PCN	Product Change Notification	De-21-05-0466	
Product	ERmet ZDplus	Date of Publication:	
		10.05.2021

Title: Modification of the female housing

ERmet ZDplus

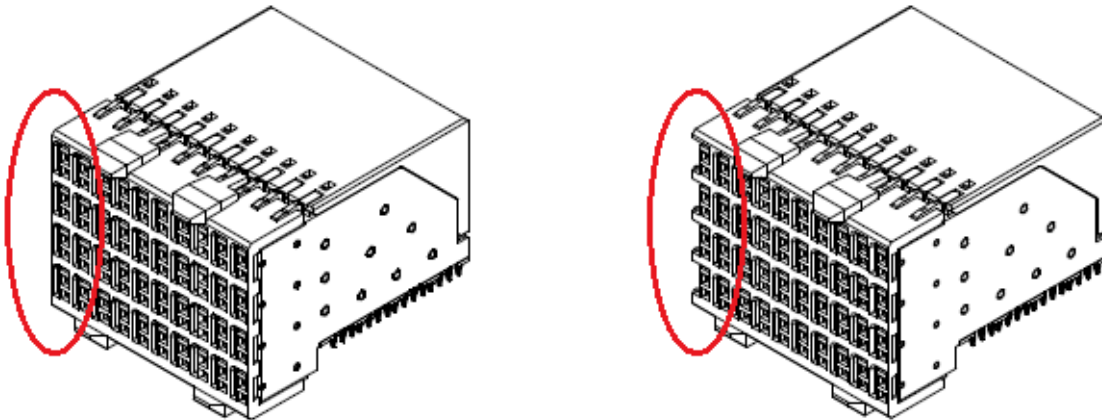
To optimize the manufacturing and handling process of the female ERmet ZDplus connector the geometry of the connector housing has changed. The bars at the mating face have been removed. This change has no influence on the mating behavior.

old geometry

new geometry
